June 5, 2000

RE: Review of Wetland 44a in Relation to Proposed Temporary Interchange at SR509 and S. 176<sup>th</sup> Street.

Map 2. Partial overlay of wetland boundaries showing location of depression in red. Note that the red shaded depression on map is shown east of the right-of-way fence whereas it actually lies west of the right-of-way map. (Scale 1"=100 feet).

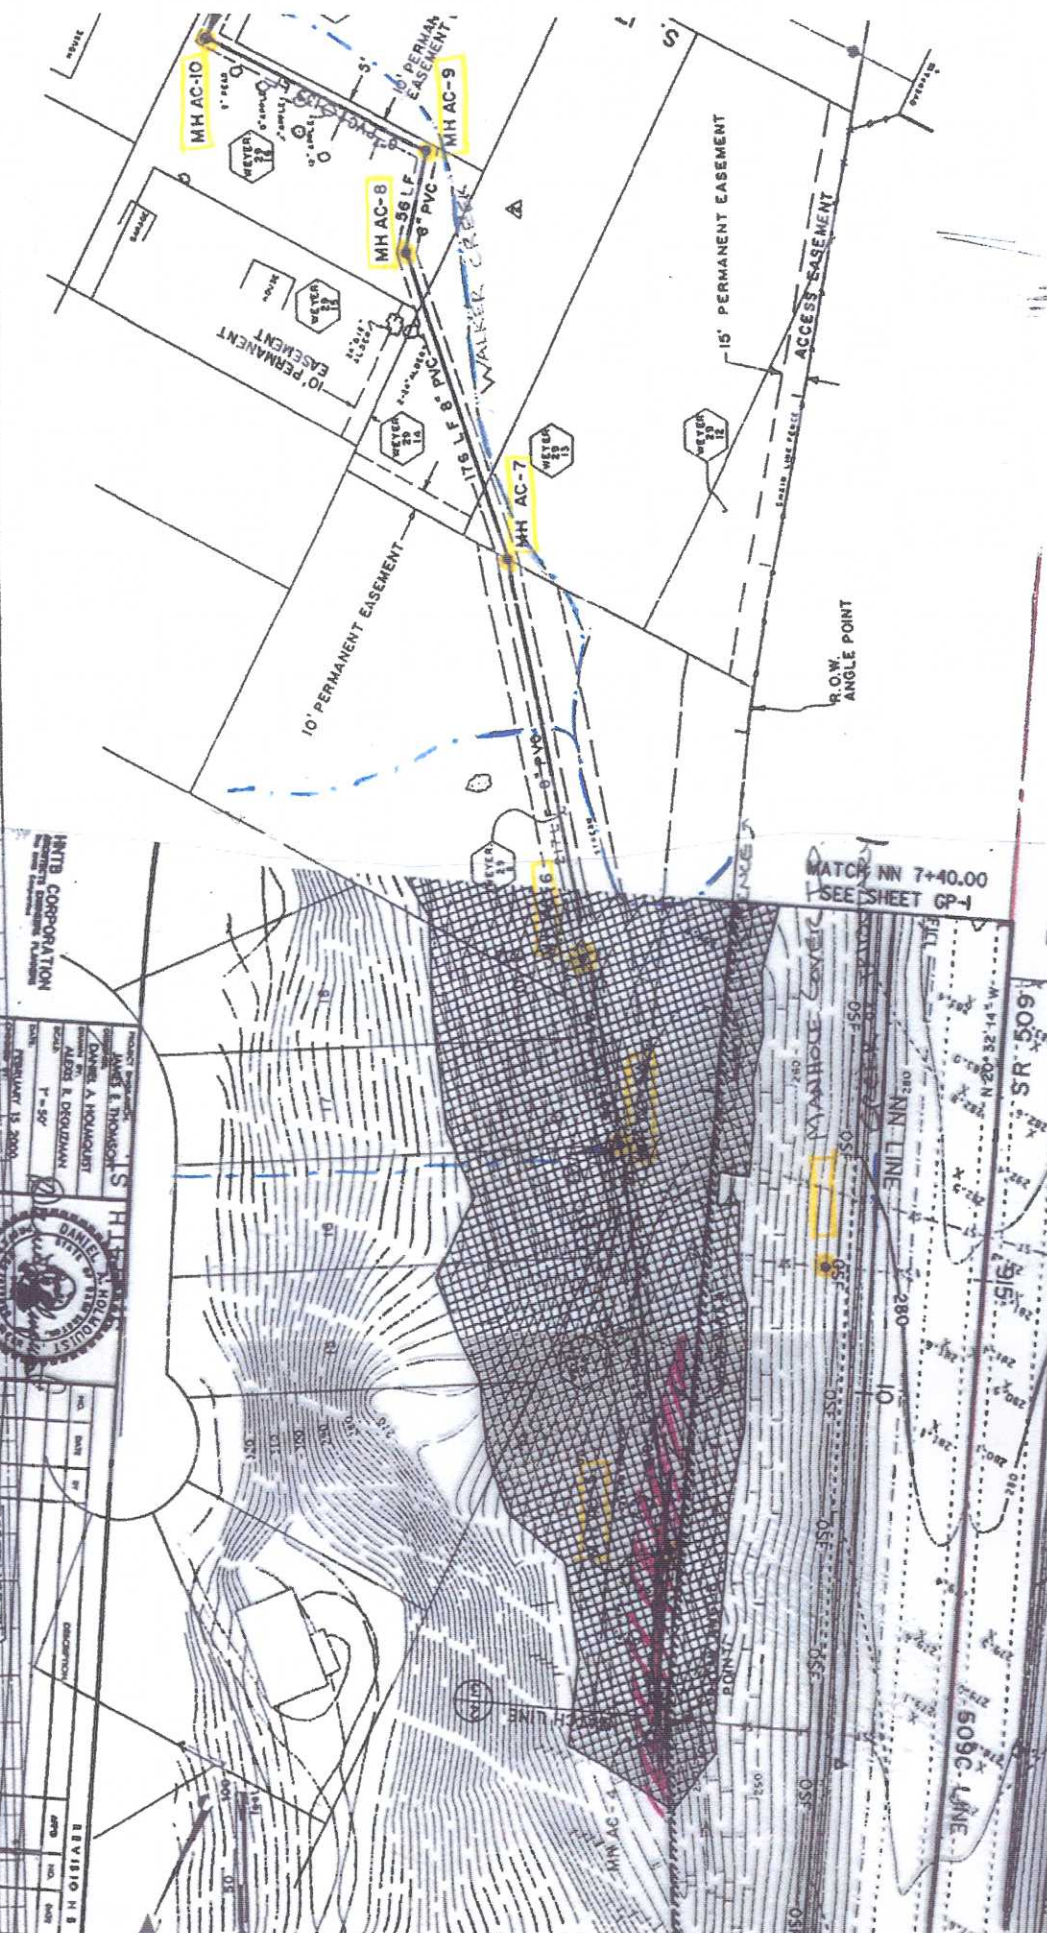
After visiting the site and reviewing the materials carefully, it is clear there is a significant discrepancy between what actual conditions are on the east side of SR509 and what is shown on sheet GP-2 Grading Plan in the project plans prepared by HNTB. Map 2 shows a portion of the GP-2 grading plan overlaid on Map 1, the sewer line plan. It is difficult to see the contours with the wetland shading superimposed but there is a depression located in the northern end of Wetland 44a. I shaded the bottom of the depression red to help you see it. During my field visit I stood on Manhole covers AC-5 and AC-5a (best seen on Map 1 on the left). From both manhole covers I saw the chain link fence located west along the right-of-way and, west of the fence, observed the depression shown in red on Map 2. From these observations, the depression appears to be located within the right-of-way, and not to the east of the right-of-way as is shown on the project plans and in the hydraulic report prepared by HNTB.

The depression I observed is clearly within the wetland and was located west of the chain link right-of-way fence. There were no other depressions in the area that could have been mistakenly identified. Based on the data available, it is reasonable to assume Wetland 44a may be 20 to 40 feet closer to SR509 than what is shown in the project plans. Under the circumstances it can be reasonably expected that significant impacts resulting from sedimentary discharges will occur to Wetland 44a as a result of the interchange construction.

In summary, the location of Wetland 44a is not correctly shown on the topography on which the project plans for the temporary interchange is based. The error, depending on its explanation, could mean the wetland is located significantly closer to the construction zone than what is shown in the project's documentation. This condition could result in significant sedimentary discharges to Wetland 44a. I hope this information is helpful. Please call if you have any questions or would like to discuss these findings further.
